ENGINE - DIFFUSER CASE - PROVIDE REPLACEMENT UNION AND GASKET SEAL AT A.C.A.C. AIR
OFFTAKE - CATEGORY CODE 6 - MOD.ENG-72-0099

V2500-ENG-72-0099

Location of union and gasket seal
Fig.1

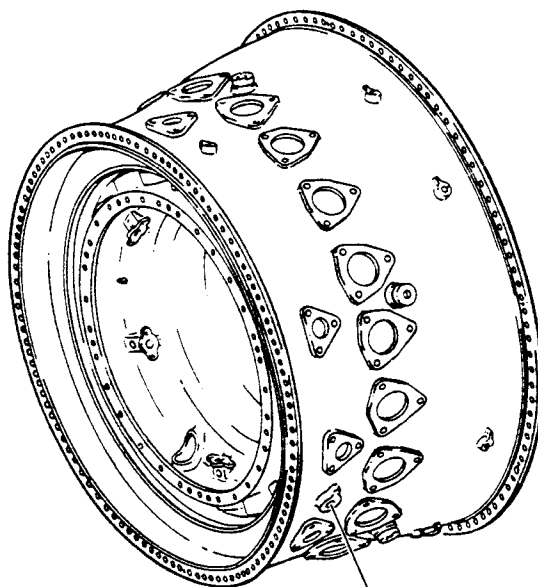
REMOVE 5W1225 (or AS3332) GASKET
AND INSTALL 6A4783 GASKET

REMOVE AS27475 UNION AND
INSTALL KU37810 UNION

- (1) Assemble new 6A4783 gasket and KU37810 union in place of 5W1225 (or AS3332) gasket and AS27475 union. Install parts by use of approved procedures, Engine Manual 72-42-00 Assembly.

NOTE: The new gasket and union must be replaced in a complete set only.
Do not mix new gasket and union with old gasket and union.
